Amendments/Additional Information

FW: 2017/0377/FL 1 Station Sq E11185-04 nymnp amends 22_06_17

Ravenscar Tearooms 1 Station Sq Ravenscar

Existing and Proposed Plans and Elevations

D11185-02

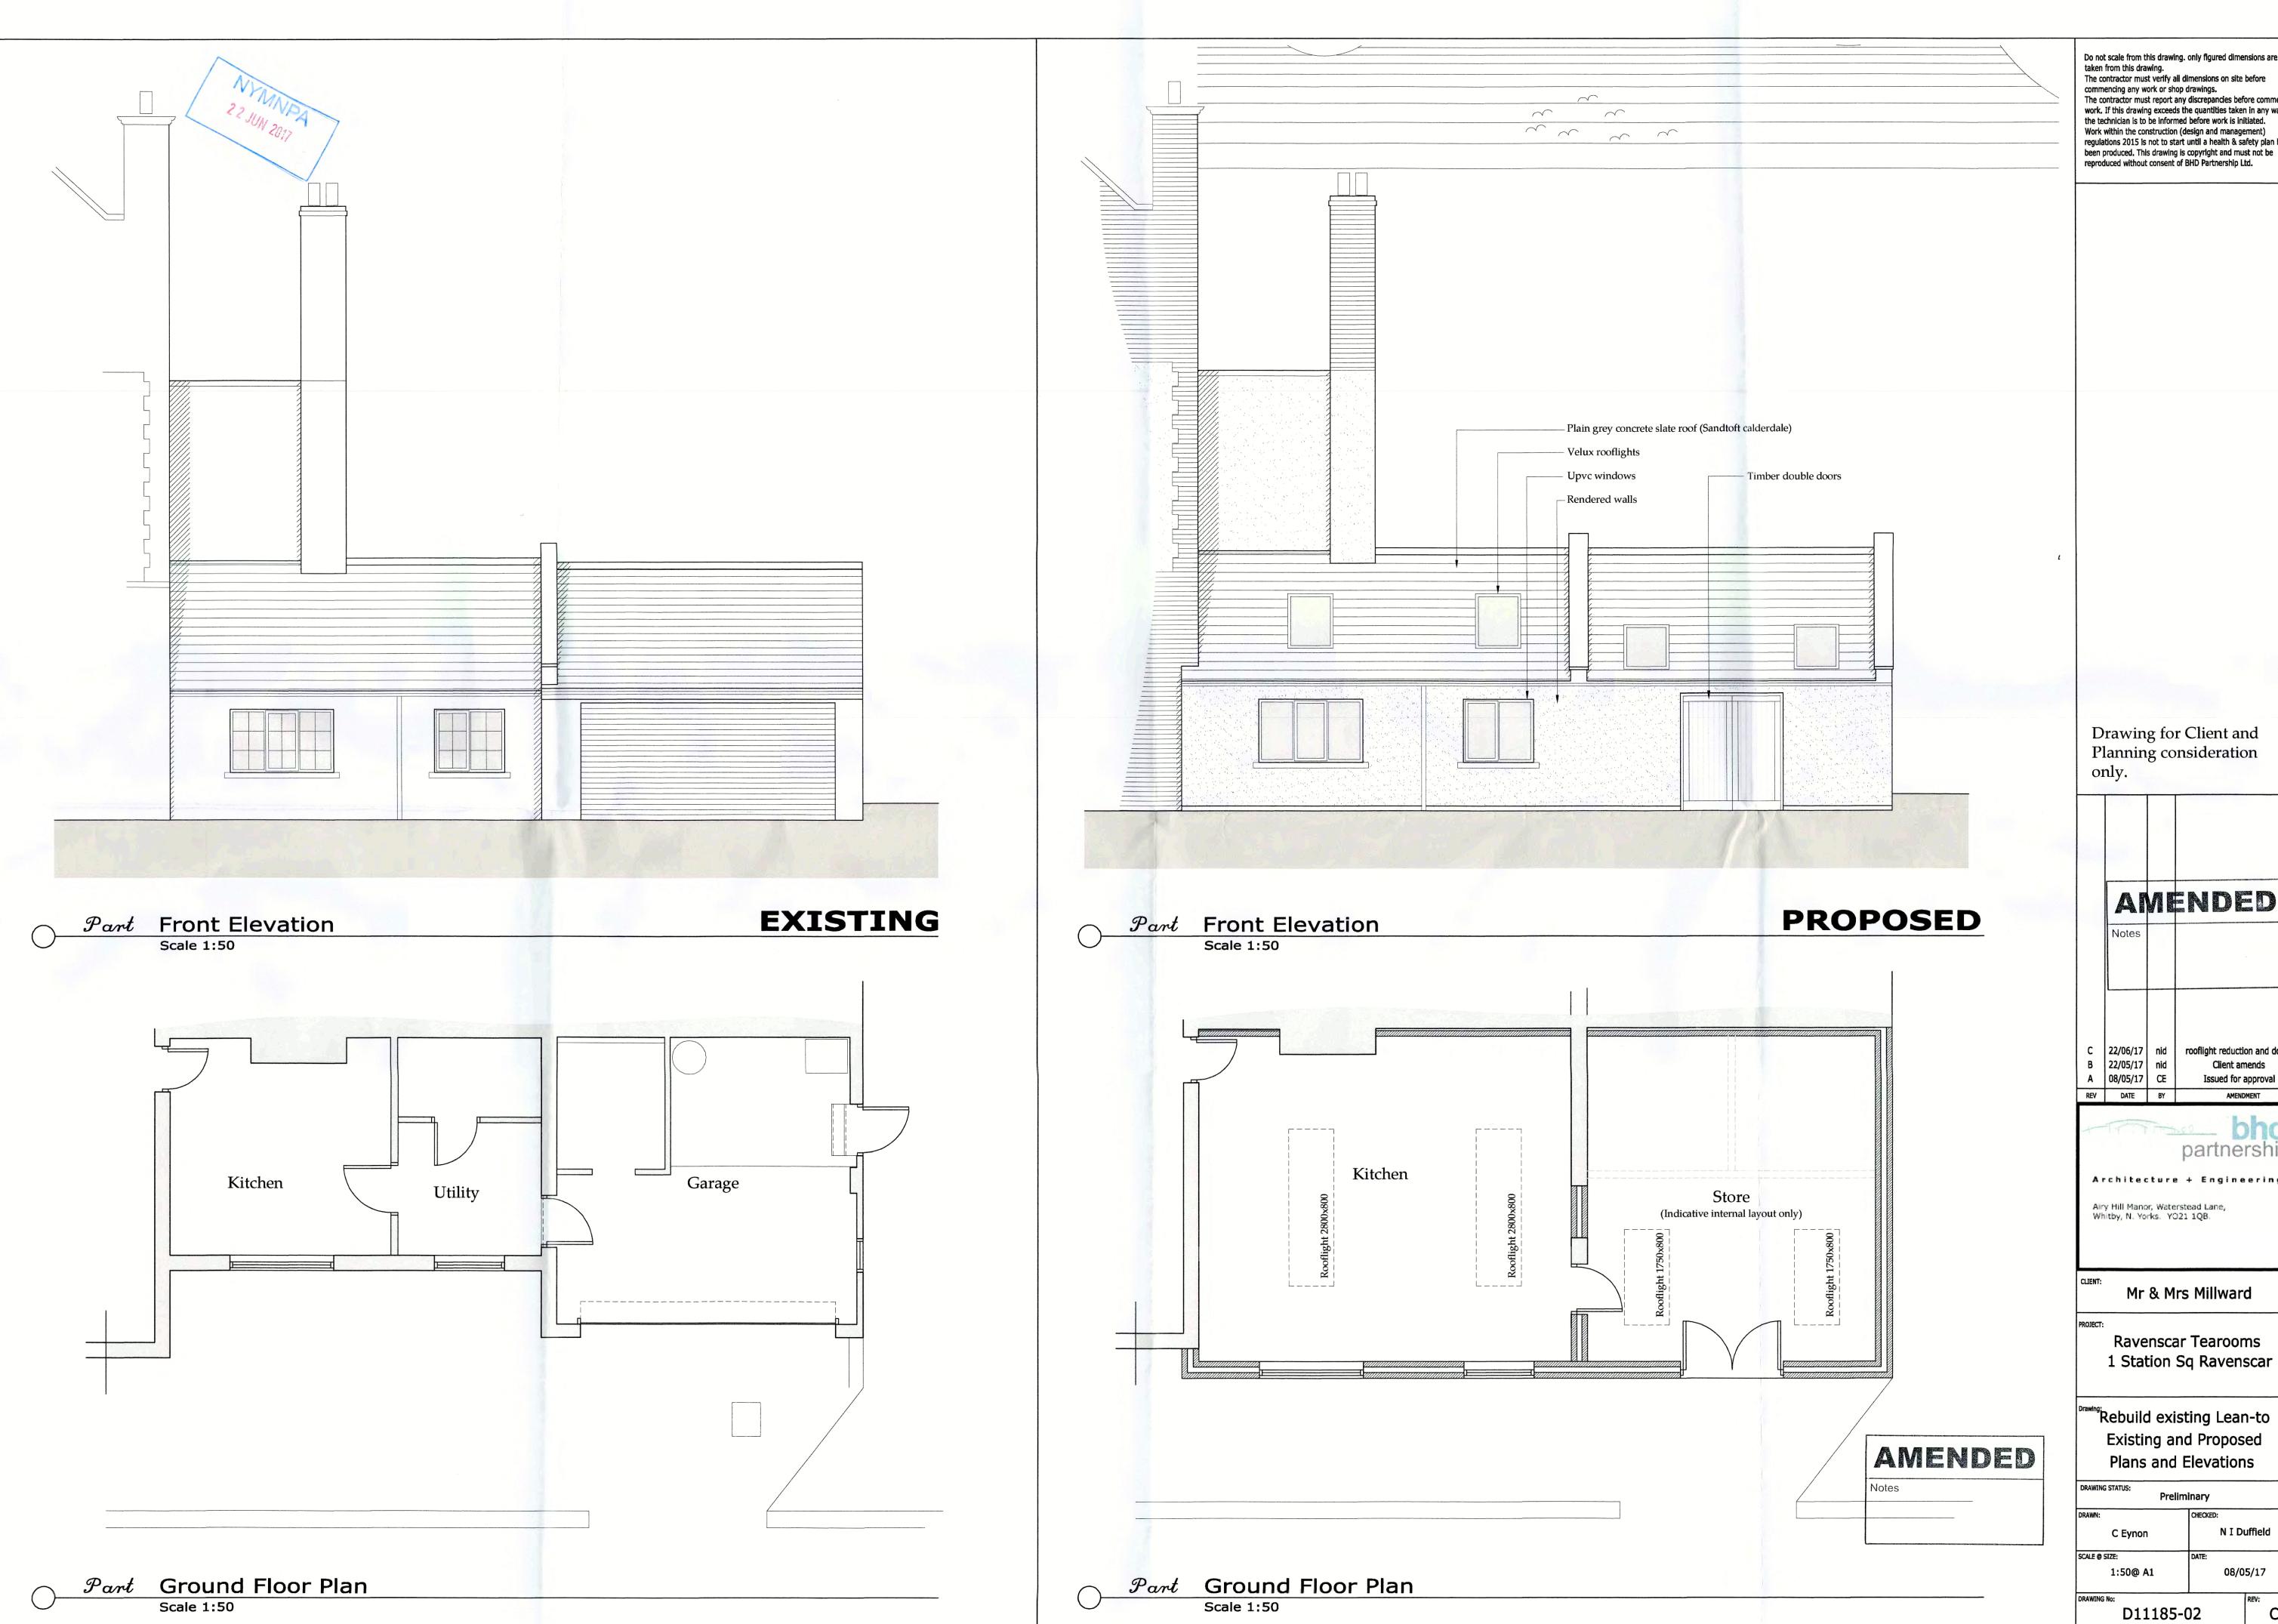
Following our conversation I have amended the drawing as agreed:-

- 2 Rooflights removed
- Rooflight sizes added
- · Double doors now solid

AMENDED C 22/06/17 nid rooflight reduction and doors Client amends Issued for approval
